PRODUCT: AUTOMATED CATWALKS
PC1000

SUBJECT: Update Terminal Blocks to Fuses

SERIAL NUMBERS: 2001 to 2005

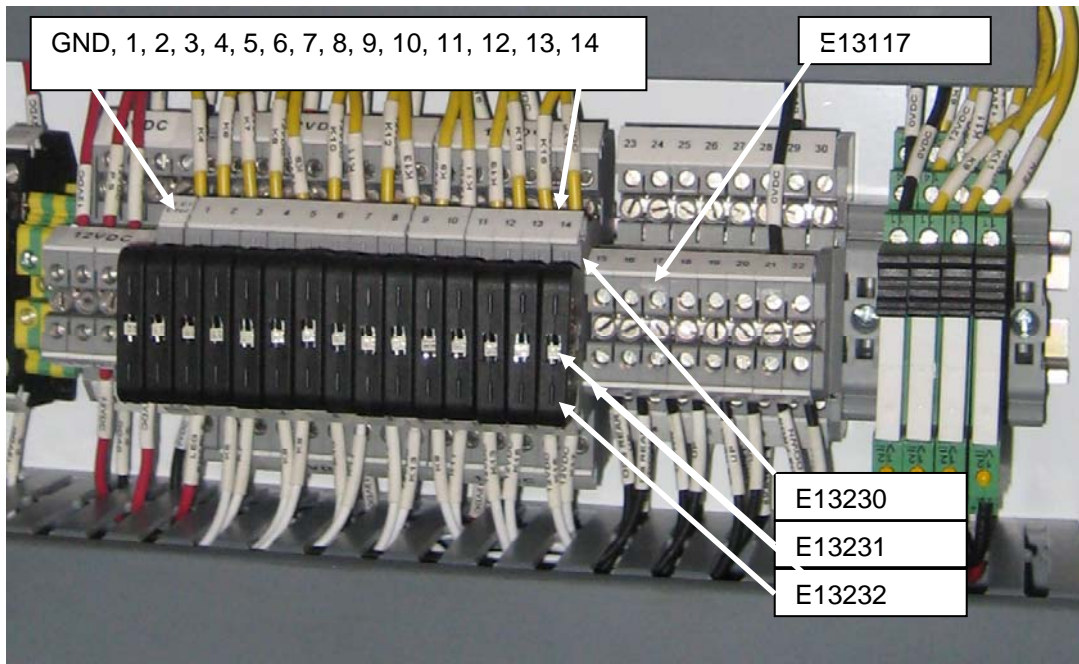
DISCUSSION: Fuses are required on the Terminal blocks to protect the radio receiver from accidental current damage.

The following Terminal blocks located in the stainless steel electrical box containing the receiver for the wireless radio should be removed and replaced with Fuse Terminal Blocks.

Terminal Blocks: GND, 1, 2, 3, 4, 5, 6, 7, 8, 9, 10, 11, 12, 13, 14

Existing Components:
E13117 Terminal Block

Replacement Components
E13230 Fuse Terminal Block
E13231 Phoenix Contact Fuse Holder
E13232 1A Fuse
